Notice regarding change to LED terminal plating due to process change.

TACTILE SWITCH B3J series
< Refer to the " [Details of applicable model] " . >

Examples of products

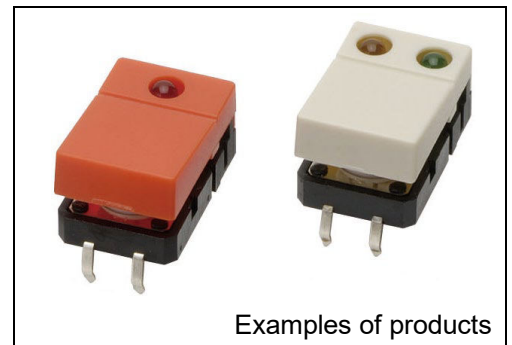
Before the change	After the change
<p>LED terminal plating</p> <p>Plating : Solder plating</p>  <p>LED terminal</p>	<p>LED terminal plating</p> <p>Plating : Tin plating</p> <p>No change in functions and specifications.</p>
